US DEPARTMENT OF ENERGY
HANFORD WASTE VITRIFICATION PLANT

DESIGN CHANGE NOTICE

DCN - 0100 | REV 1 | PAGE 1 OF 18

DCN TITLE: THIS DCN-0100 SUPERSEDES "DCN-0096" & "DCN-0096 REV 1"

SECTION CH 119279

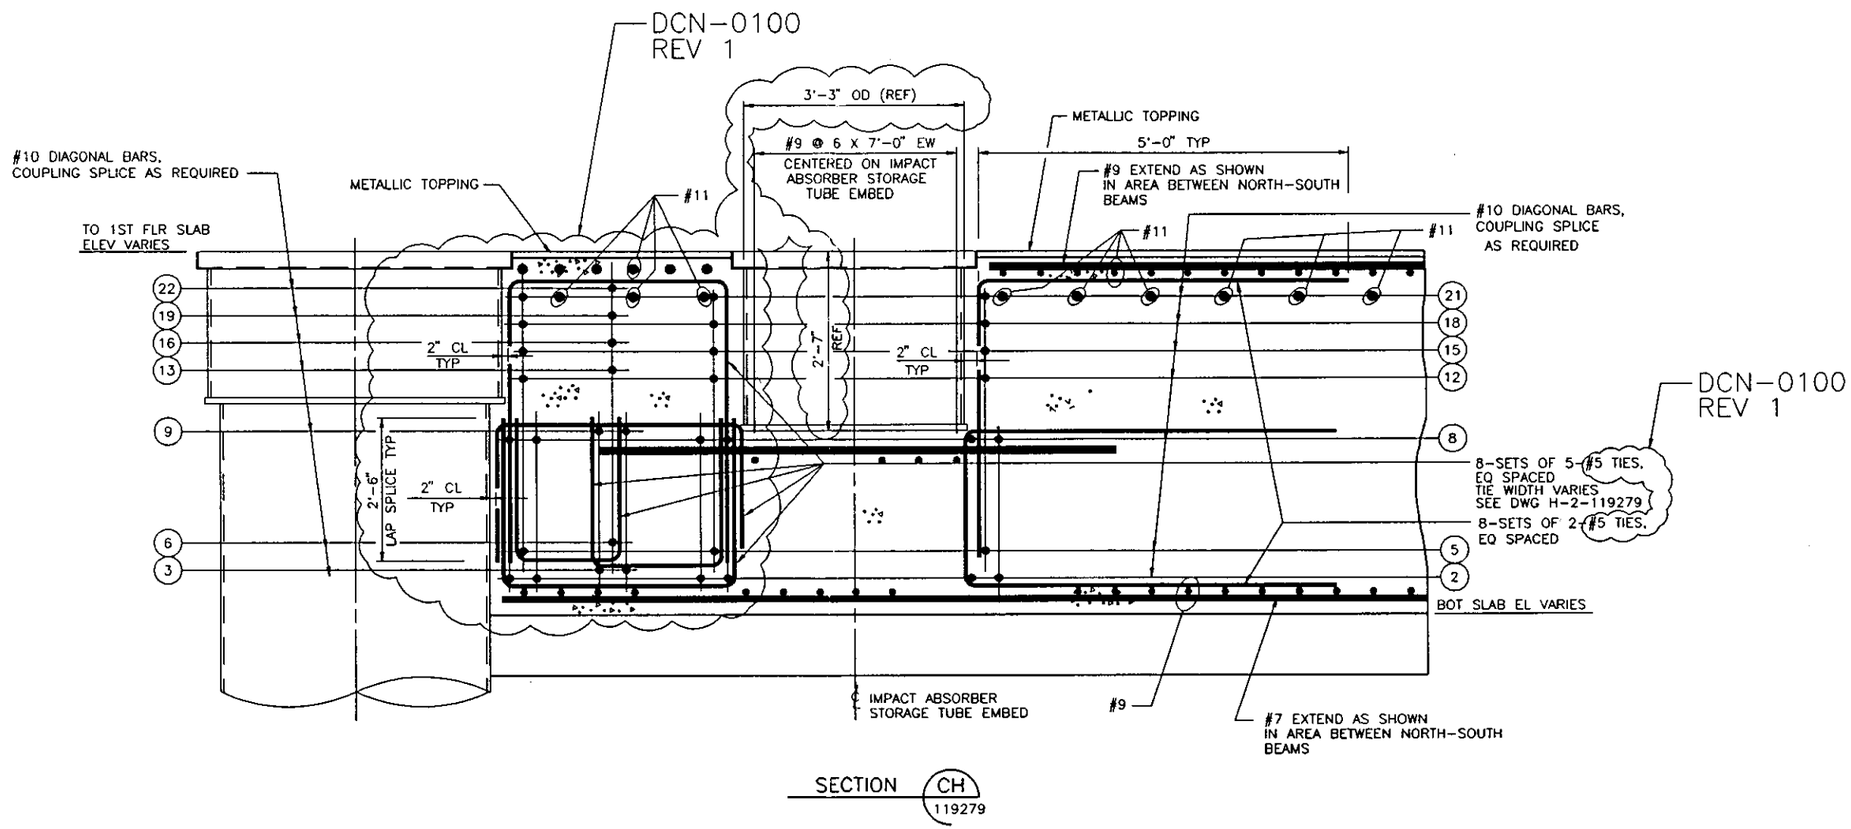
FLUOR DANIEL	U.S. DEPARTMENT OF ENERGY HANFORD WASTE VITRIFICATION PLANT	DESIGN CHANGE NOTICE
DESCRIPTION OF CHANGE REMOVE HOLD HWVP-FD-372. REVISE REINFORCING TIES. REVISE IMPACT ABSORBER STORAGE TUBE EMBED DIMENSIONS.		BASE DOC. NO. H-2-119280 SHT/PG. 3 REV. 1 CR NO. CR-HWVP-1025 DISCIPLINE: STRUCTURAL/DCN0096R
PREPARED BY: Armando Villegas	DATE: 9/28/93	DCN - 0100 REV. 1 PAGE 11
DISCIPLINE ENGINEER: Robert J. Smalber	DATE: 9-28-93

DETAIL 98 / 119276

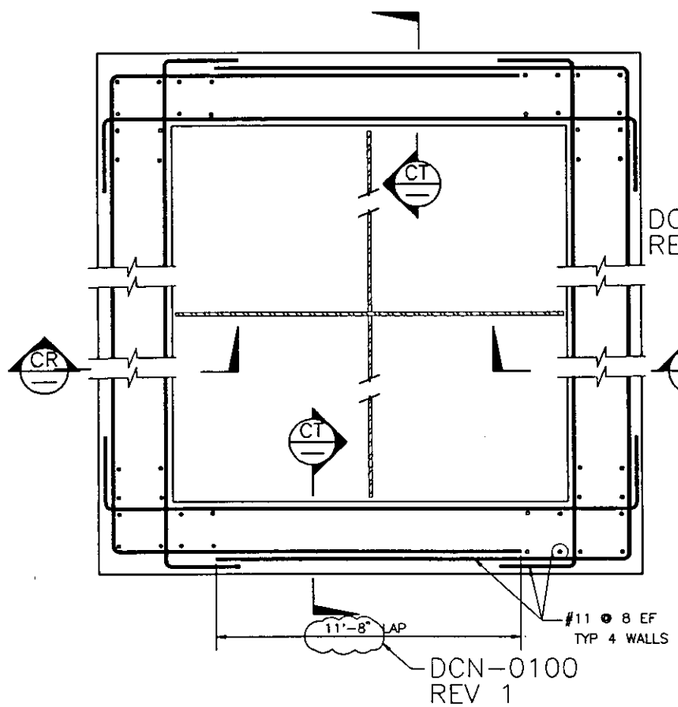
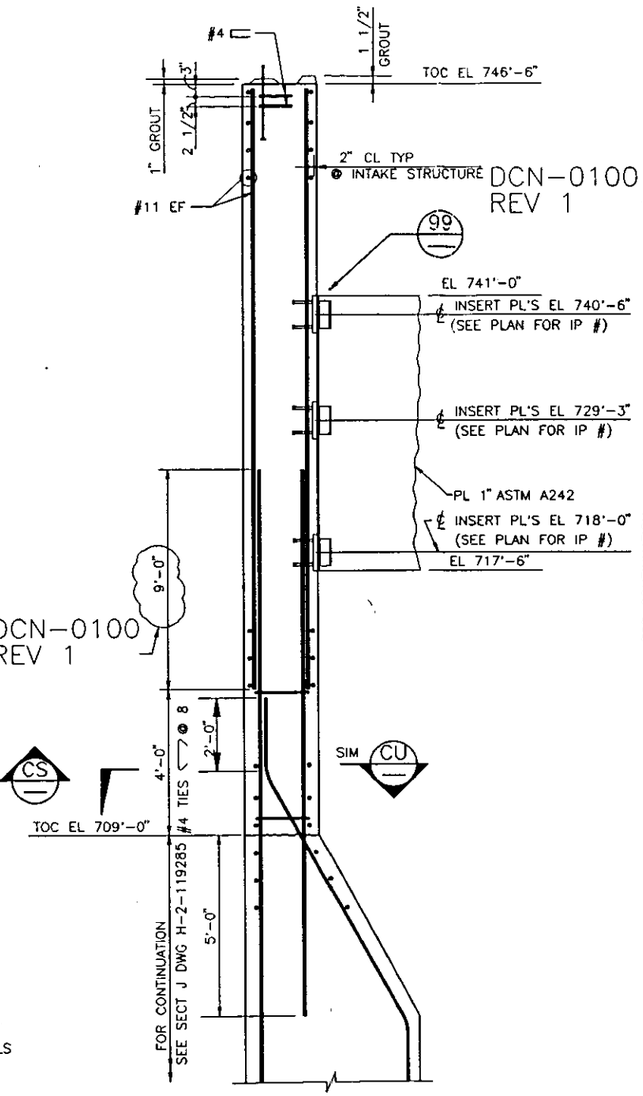
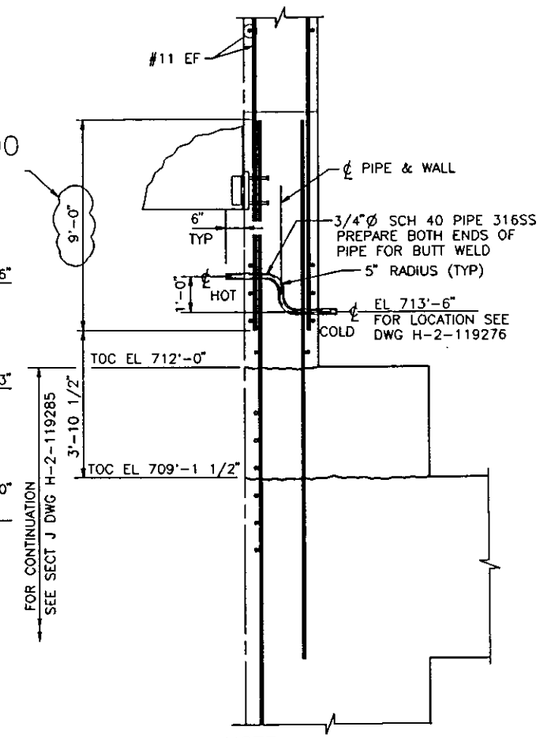
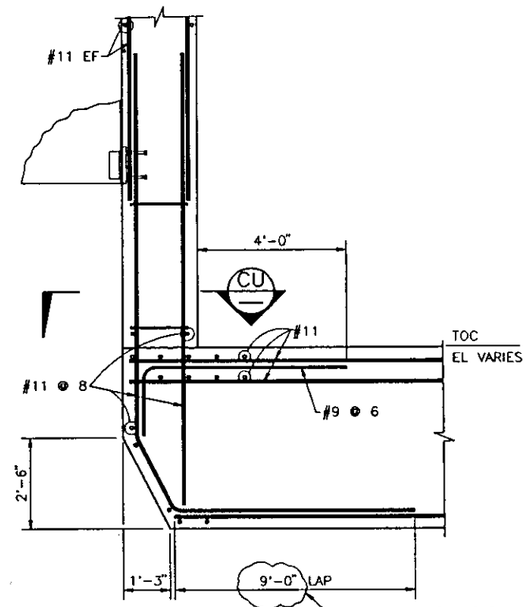
FLUOR DANIEL — U.S. DEPARTMENT OF ENERGY, HANFORD WASTE VITRIFICATION PLANT		DESIGN CHANGE NOTICE
DESCRIPTION OF CHANGE: REMOVE HOLD HWVP-FD-372. REVISE REINFORCING LAPS.		BASE DOC. NO. H-2-119280; SHT/PG. 3; REV. 1; CR NO. CR-HWVP-1025; DISCIPLINE: STRUCTURAL/DCN0096S
PREPARED BY: Armando Villegas	DATE: 9/28/93	DCN - 0100 / REV. 1 / PAGE 12
DISCIPLINE ENGINEER: Robert D. Stubbers	DATE: 9/28/93

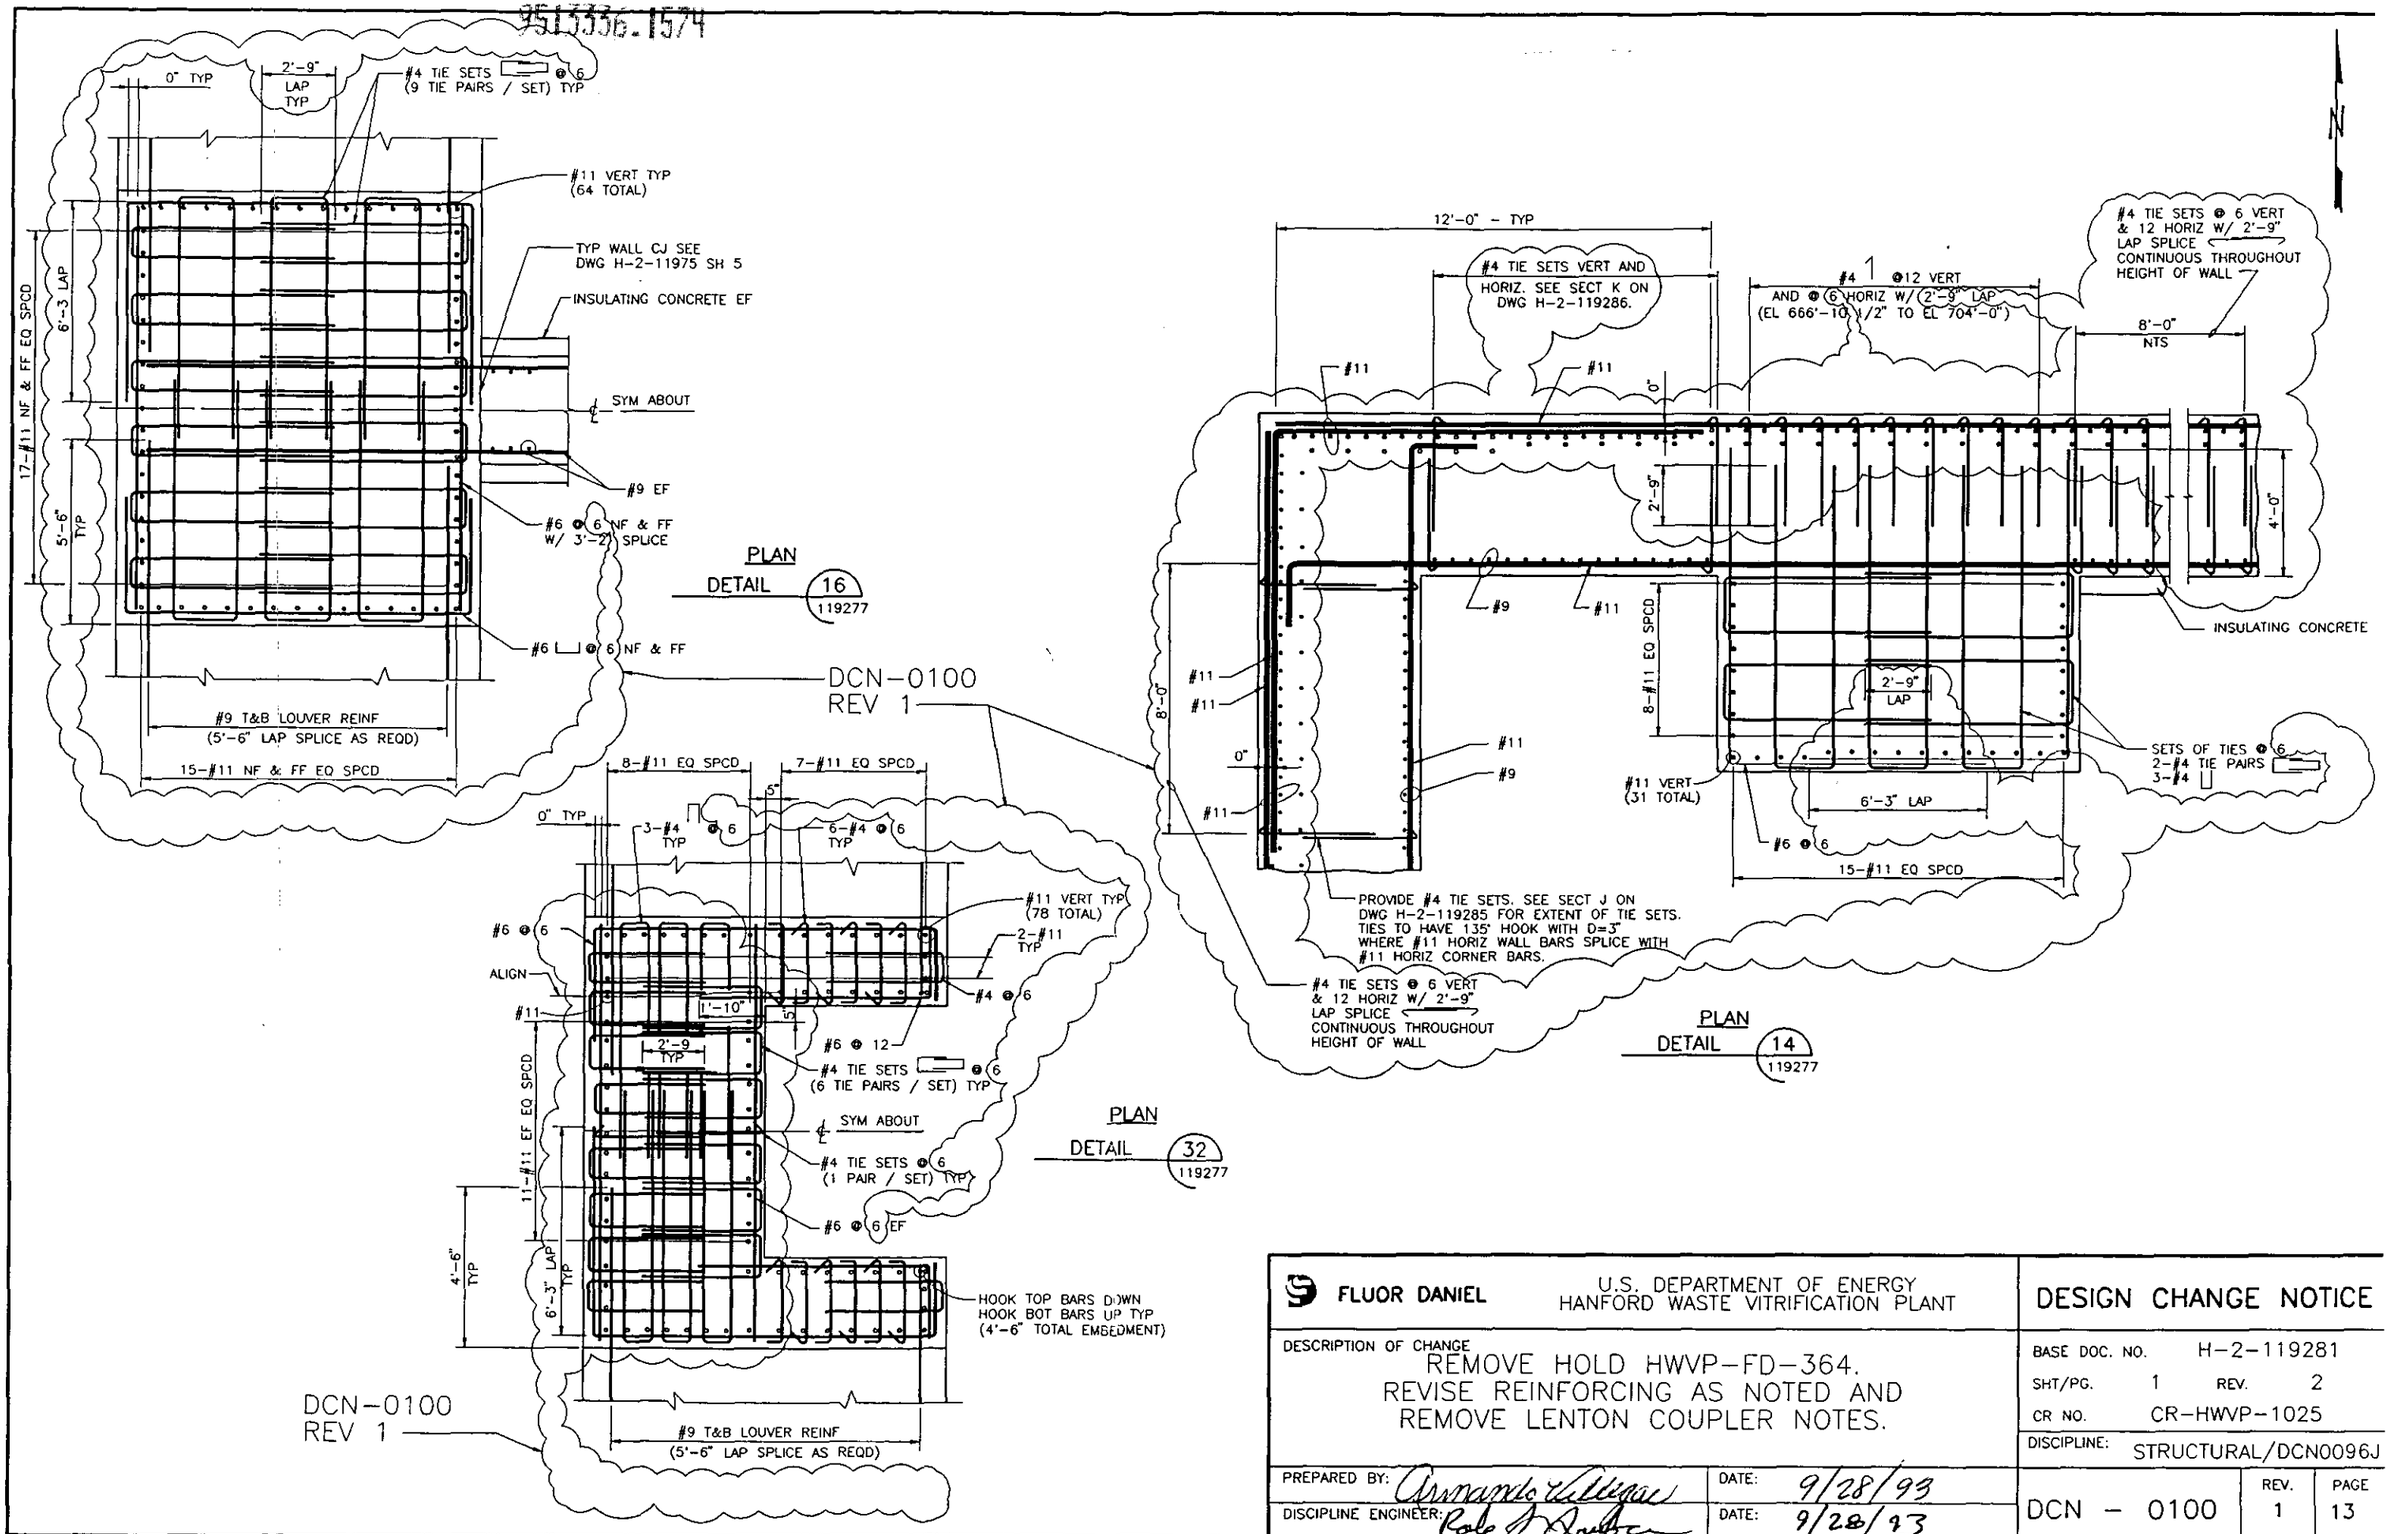
FLUOR DANIEL	U.S. DEPARTMENT OF ENERGY HANFORD WASTE VITRIFICATION PLANT	DESIGN CHANGE NOTICE
DESCRIPTION OF CHANGE REMOVE HOLD HWVP-FD-364. REVISE REINFORCING AS NOTED AND REMOVE LENTON COUPLER NOTES.		BASE DOC. NO. H-2-119281 SHT/PG. 1 REV. 2 CR NO. CR-HWVP-1025 DISCIPLINE: STRUCTURAL/DCN0096J
PREPARED BY: Armando Villegas	DATE: 9/28/93	DCN - 0100 REV. 1 PAGE 13
DISCIPLINE ENGINEER: Robert J. Dubois	DATE: 9/28/93

DETAIL 15 / 119277

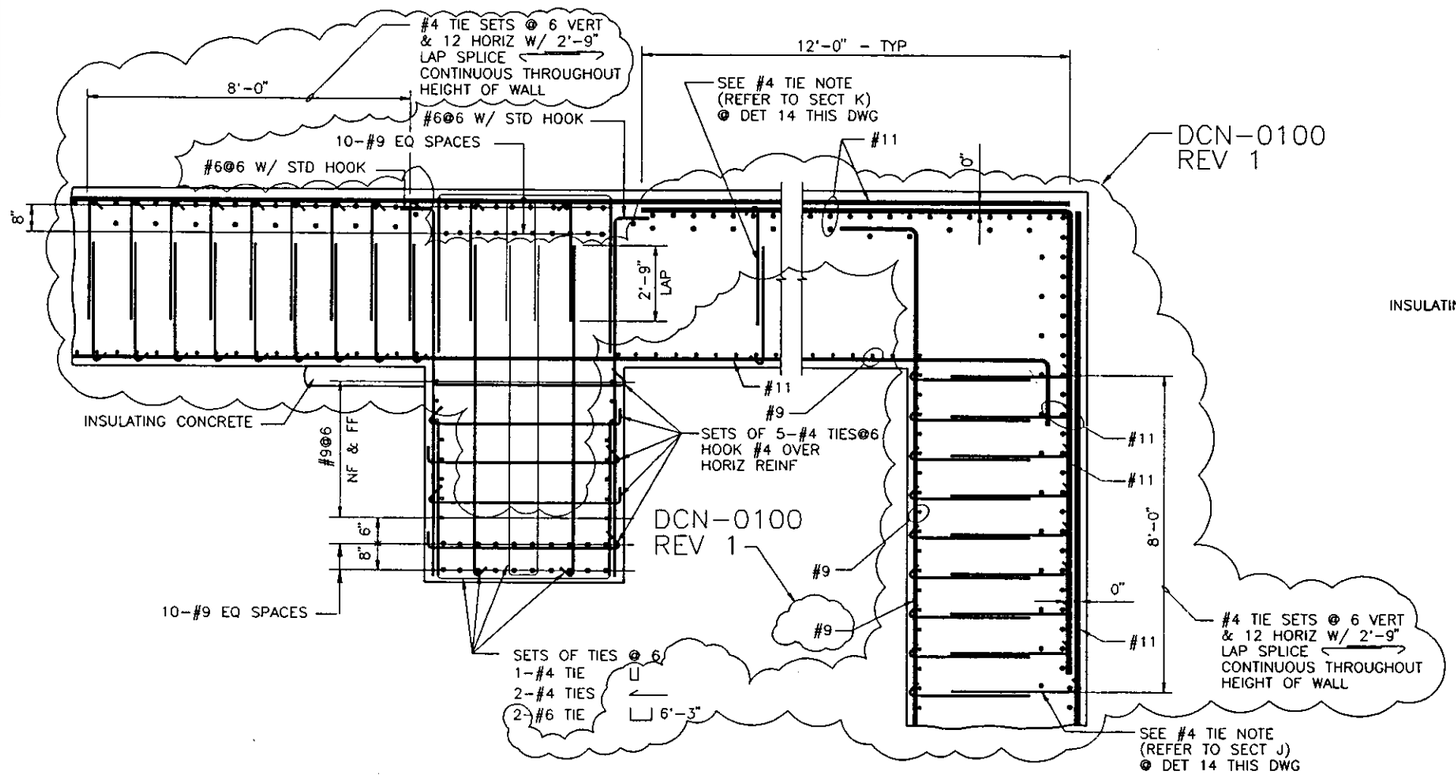
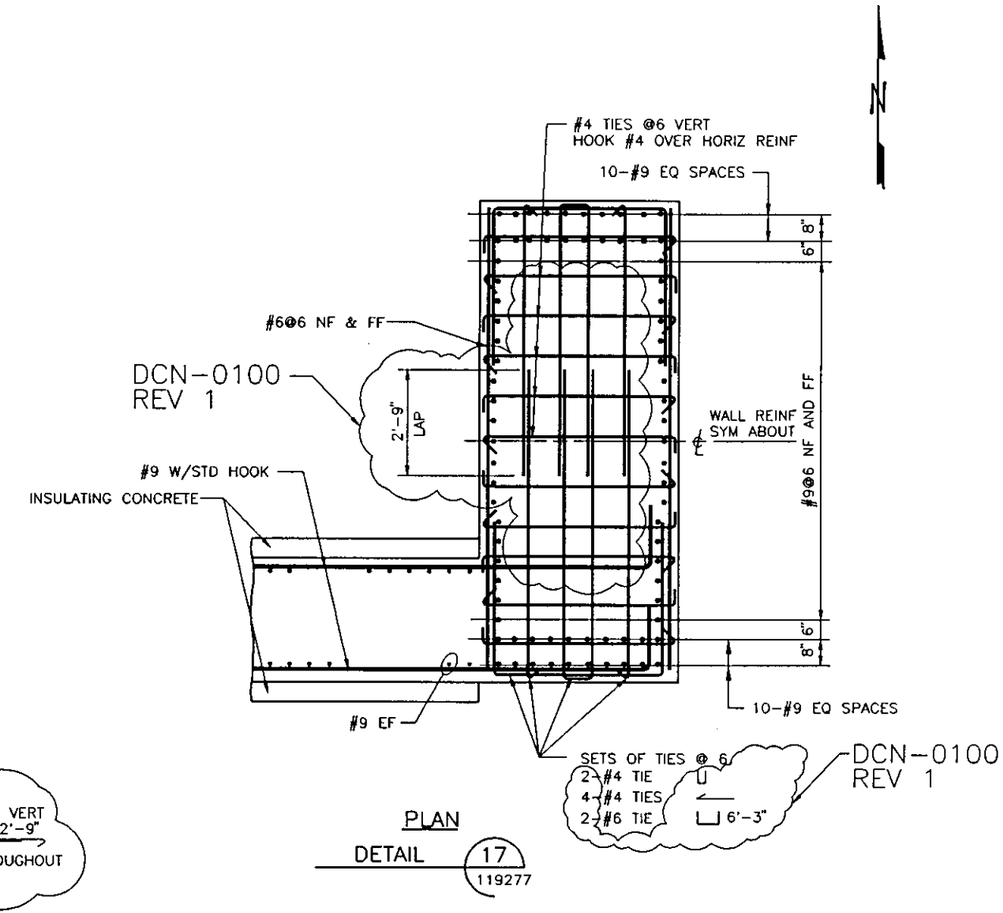
REVISE HORIZONTAL REINFORCING BAR AS INDICATED WITH "DCN-0100 REV 1" ON PAGE 14.

FLUOR DANIEL — U.S. DEPARTMENT OF ENERGY, HANFORD WASTE VITRIFICATION PLANT		DESIGN CHANGE NOTICE
DESCRIPTION OF CHANGE: REMOVE HOLD HWVP-FD-364. REVISE REINFORCING AS NOTED.		BASE DOC. NO. H-2-119281; SHT/PG. 1; REV. 2; CR NO. CR-HWVP-1025; DISCIPLINE: STRUCTURAL/DCN0096K
PREPARED BY: Armando Villegas	DATE: 9/28/93	DCN - 0100 — REV. 1 — PAGE 14
DISCIPLINE ENGINEER: Robert A. Smith	DATE: 9/28/93

SECTION CP 119279

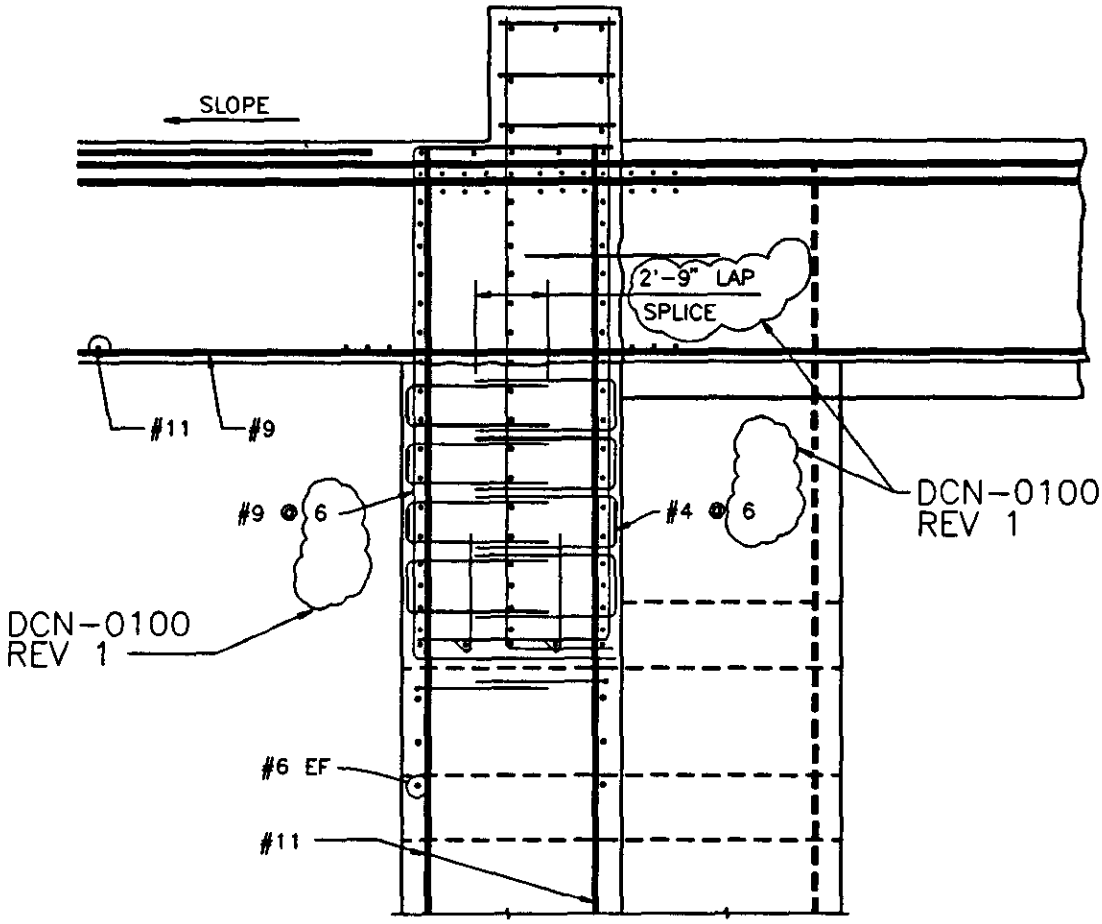
FLUOR DANIEL	U.S. DEPARTMENT OF ENERGY HANFORD WASTE VITRIFICATION PLANT	DESIGN CHANGE NOTICE
DESCRIPTION OF CHANGE: REMOVE HOLD HWVP-FD-364. REVISE REINFORCING SPACING AND TIE LAP AS NOTED.		BASE DOC. NO. H-2-119281 SHT/PG. 2 REV. 0 CR NO. CR-HWVP-1025 DISCIPLINE: STRUCTURAL/DCN0096H
PREPARED BY: Armanda Gillegan	DATE: 9/28/93	DCN - 0100 REV. 1 PAGE 15
DISCIPLINE ENGINEER: [signature]	DATE: 9-28-93
